Ball Switch Removal From Strapper

Condition: In some instances the ball switches that sense bundle presence in the strapper may operate erratically and cause inaccurate strapping of the bundles. This erratic operation has been eliminated by removal of the ball switches and additional wiring and software changes to the control system within the Quipp Packman.

This section describes the necessary wiring
## changes to the strapper portion of the Quipp Packman

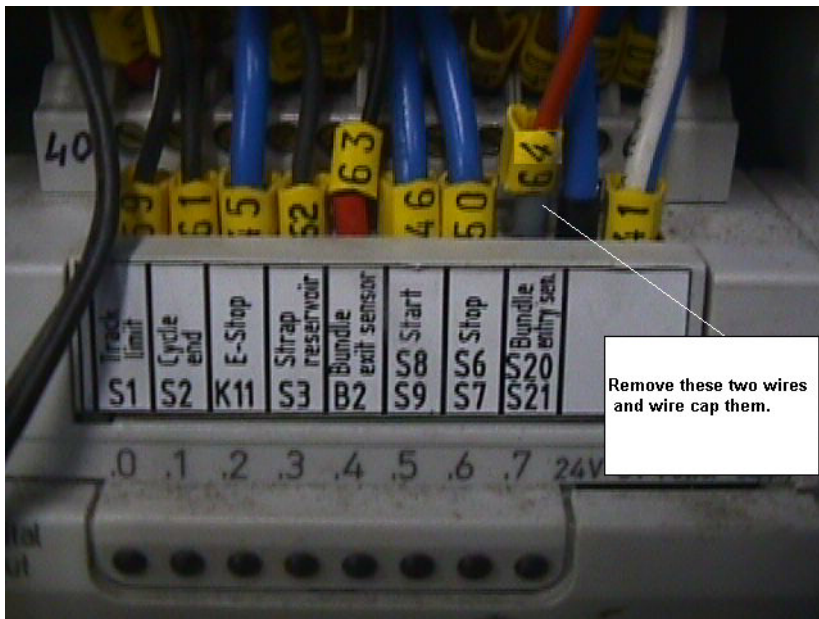
6. Disconnect the ball switches S20 and S21 - two wires from input I0.0.7.

Remove these two wires and wire cap them.

7. The two wires from the ball switches are shown capped off.

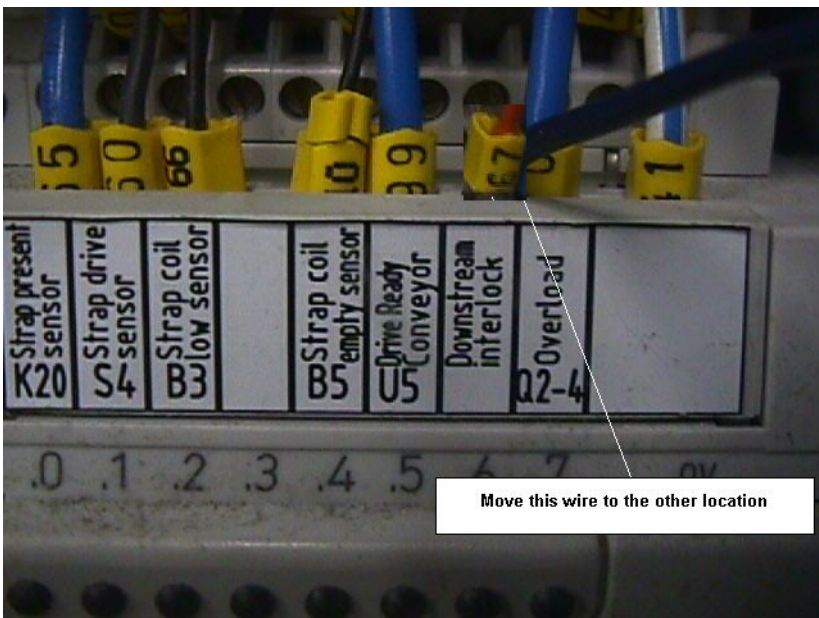
8. Disconnect the Quipp Packman "Downstream interlock" signal wire X1/16 from input I1.0.6.

Move this wire to the other location

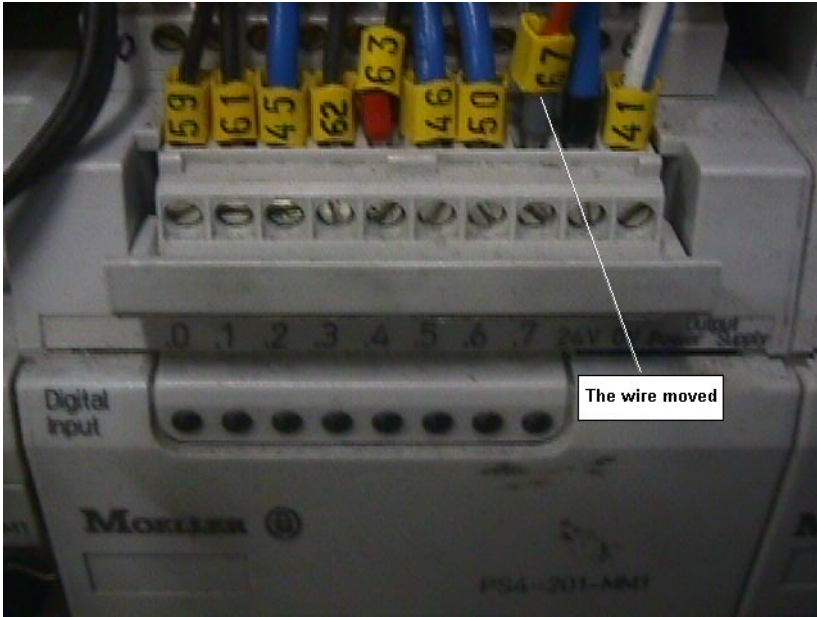
9. Connect Quipp Packman "Downstream interlock" signal wire X1/16 to input I0.0.7, where the ball switch signals had previously been connected.

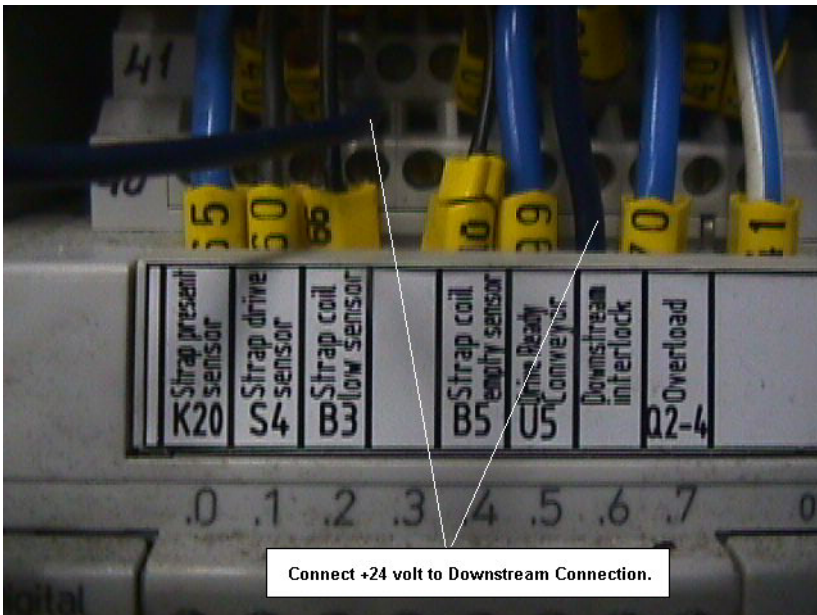
10. Connect input I1.0.6 to +24VDC.

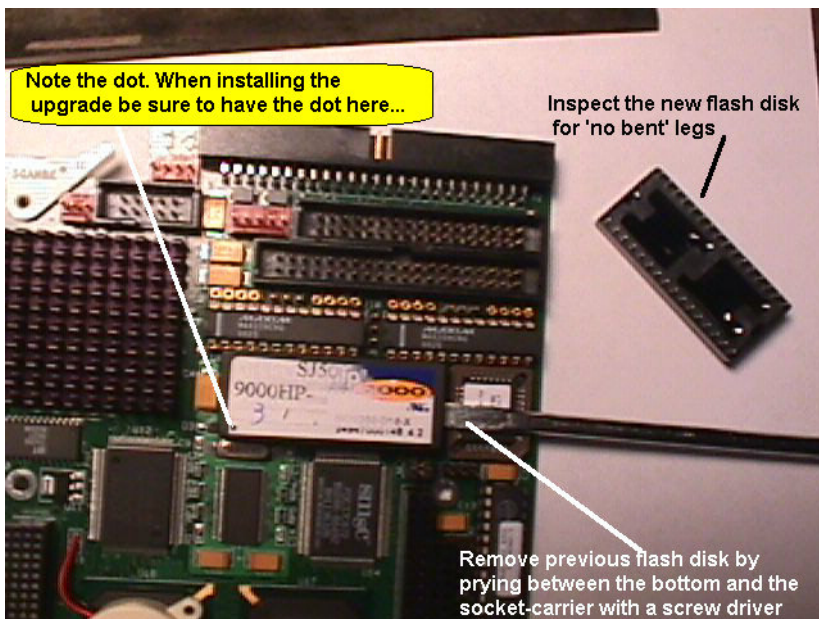
11. Replace the existing Quipp Packman memory flash chip with new chip p/n 9000HP-32200, revision date 2/10/06 or greater. Use the following steps 12 through 21 to replace the flash chip.
12. Make a record of any parameters that are different from the default values. These values will be lost and will have to be reentered after the flash chip change.

Note the dot. When installing the upgrade be sure to have the dot here...

Inspect the new flash disk for 'no bent' legs

Remove previous flash disk by prying between the bottom and the socket-carrier with a screw driver
